2.5 Geology, Seismology, and Geotechnical Engineering

In Section 2.5, “Geology, Seismology, and Geotechnical Engineering,” of the site safety analysis report (SSAR), the applicant described the geological, seismological, and geotechnical engineering properties of the early site permit (ESP) site. SSAR Section 2.5.1, “Site and Regional Geology,” describes the basic geological and seismological data for the site and region surrounding the site. SSAR Section 2.5.2, “Vibratory Ground Motions,” describes the vibratory ground motion for the ESP site through a probabilistic seismic hazard analysis (PSHA) and develops the safe-shutdown earthquake (SSE) ground motion. SSAR Section 2.5.3, “Surface Faulting,” describes the potential for surface faulting at or near the surface of the ESP site. SSAR Section 2.5.4, “Stability of Subsurface Materials and Foundations,” presents information on the stability of the ESP site’s subsurface materials. SSAR Section 2.5.5, “Stability of Slopes,” defers the analysis of slope stability to the combined license (COL) application. Similarly, SSAR Section 2.5.6, “Embankments and Dams,” defers the reanalyses of the Clinton Power Station (CPS) ultimate heat sink

Figure 2.5.4-2 G/G_{\max} plot resonant column and cyclic torsion test results

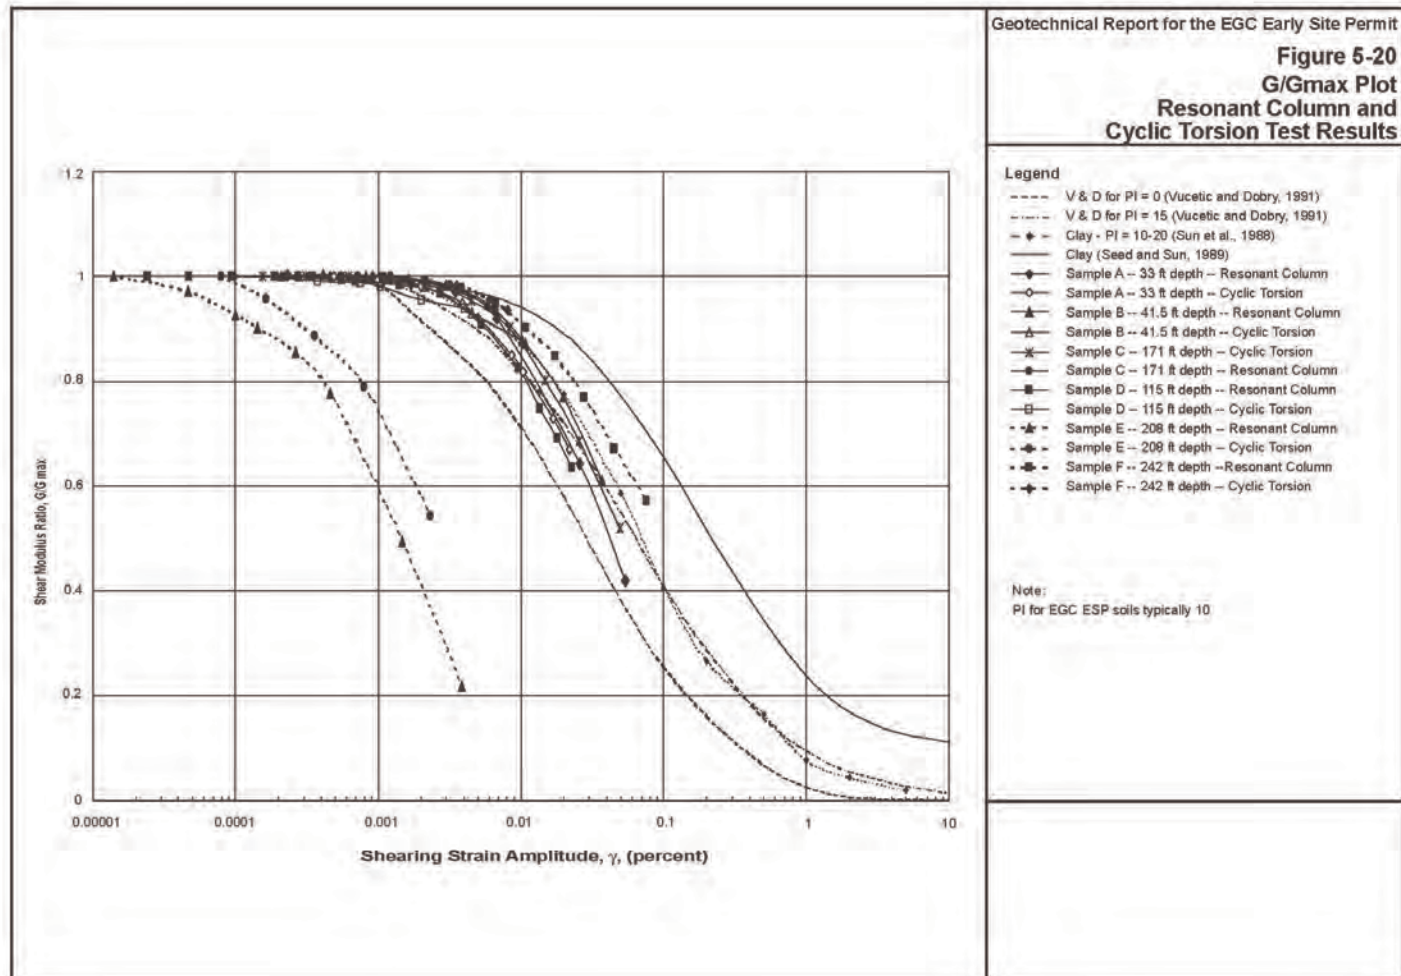
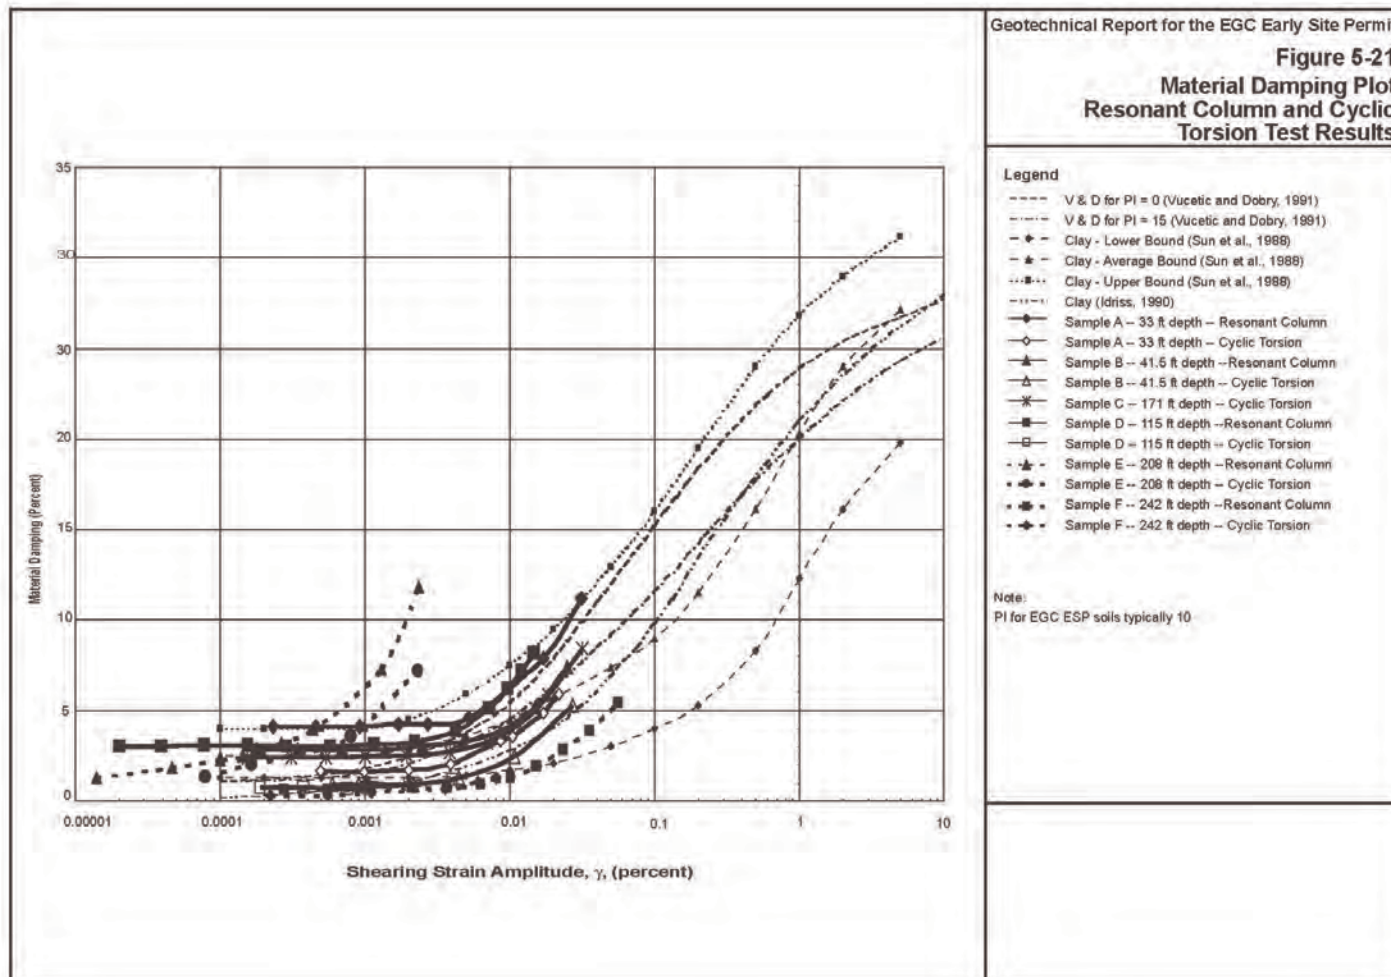
In RAI 2.5.4-2, the staff asked the applicant to justify its use of the EPRI curves and to further explain its basis for concluding that the ESP site soils are consistent with those used to develop the EPRI curves. In response to RAI 2.5.4-2, the applicant stated that the EPRI curves it used represent soils in the general range of gravelly sands to low-plasticity silty or sandy clays and that soils at the ESP site fall within this category of soils. SER Section 2.5.4.3.2 provides a complete description of the applicant's response to RAI 2.5.4-2 and the staff's evaluation of this response.

The information in Figure 5-21 (SSAR Appendix A) does indeed suggest that the hysteric damping from the laboratory tests was higher than the EPRI curves.

The same conclusion can be made from the information in Figure 5-24. However, the curves that are above the EPRI damping curves are related to the resonant column tests. The fact that the resonant column data shown in Figures 5-21 and 5-24 are solid, bold lines masks the response from the torsional shear tests—suggesting that all the damping values are too high at low shearing strain amplitudes. However, material damping values from the torsional shear tests are consistent with the EPRI damping curves, as shown in Figures 4.2-2 through 4.2-6 of Appendix B to the EGC ESP SSAR.

Figure 2.5.4-6 Modulus reduction and damping test results compared to EPRI (1993) soil property curves for test UTA-34-A

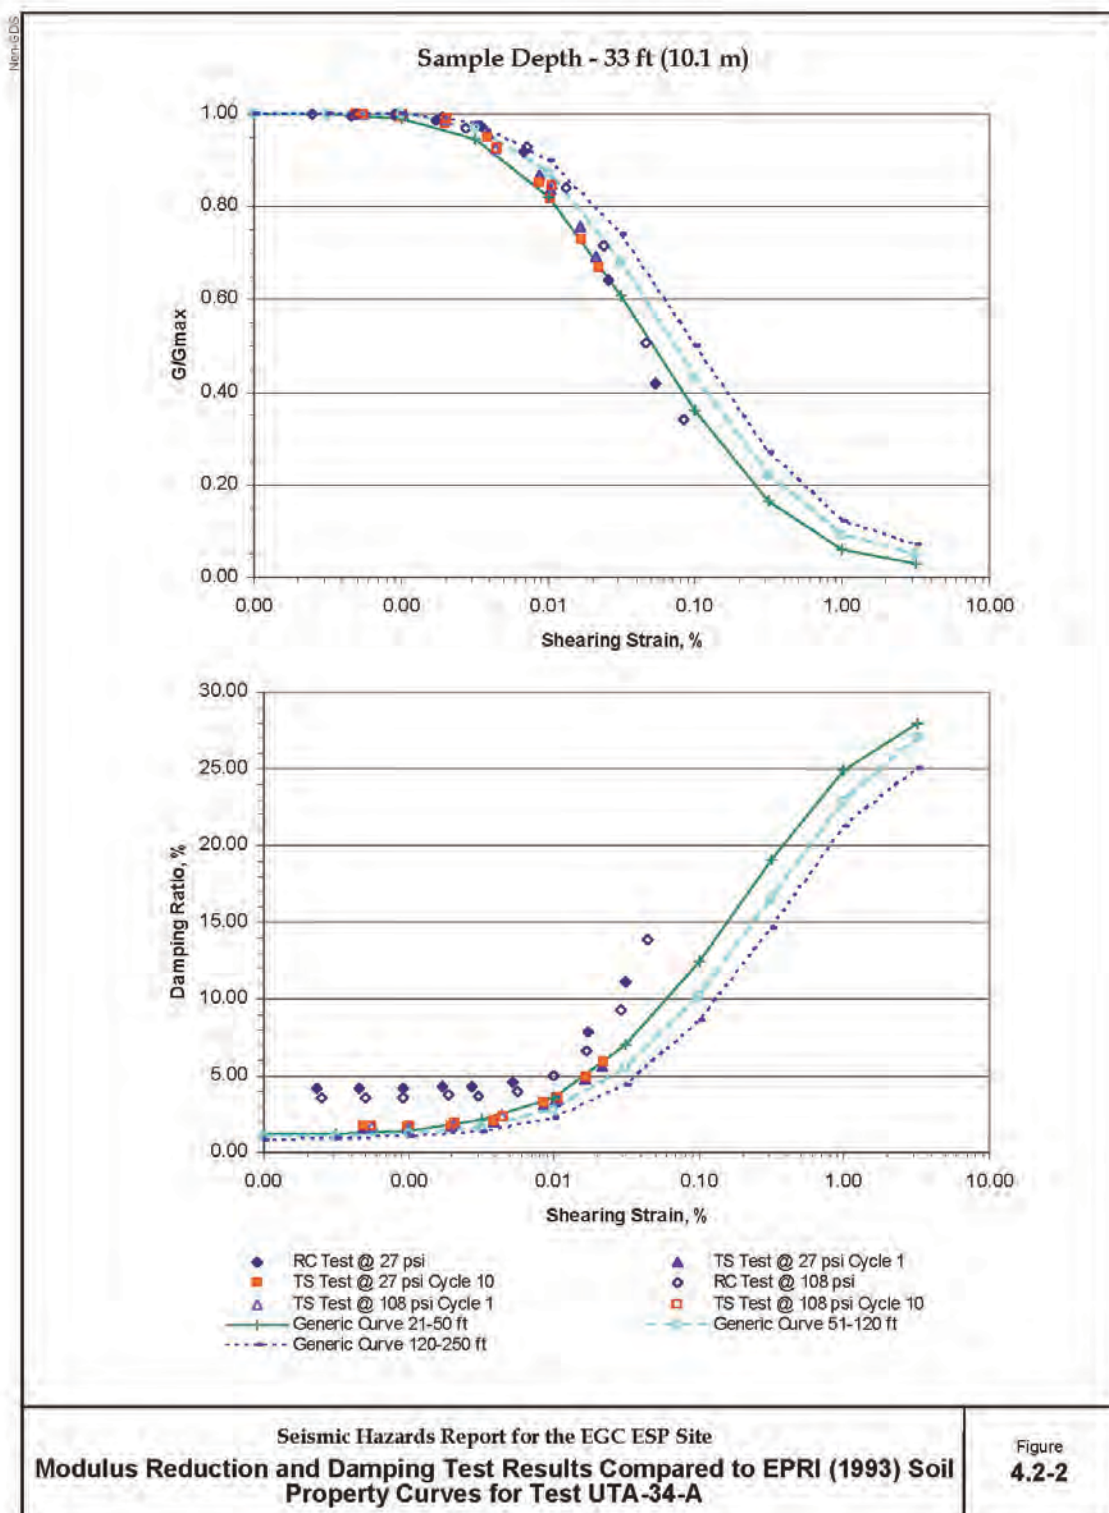
In order to verify the applicant's classification of the ESP soils as "gravelly sands to low plasticity silty and sandy clays," the staff reviewed Section 5.2.2 of SSAR Appendix A. Section 5.2.2 provides a general description of each of the soil layers underlying the ESP site and includes information on plasticity, water content, and dry density. The staff concludes from its review that the applicant's characterization of the ESP site soils is appropriate. In addition, the staff concludes that the applicant's use of the EPRI curves is justified since these curves are based on a much larger database of properties from similar soils (gravelly sands) than those obtained by the applicant for the ESP site from its four soil borings. Although the fit between the EPRI curves and the resonant column tests on the ESP site soils is weak, the staff notes that the torsional shear test data do fit the EPRI curves. The frequency of loading for the torsional shear tests ranges from 0.1 to 10 Hz, which is consistent with the predominant frequencies of earthquake ground motion. Figure 2.5.4-6, which reproduces Figure 4.2-2 from

SSAR Appendix B, shows the fit between the ESP site data from the resonant column and torsional shear tests compared to the EPRI (1993) generic curves for gravelly sands to low-plasticity silty or sand clays.
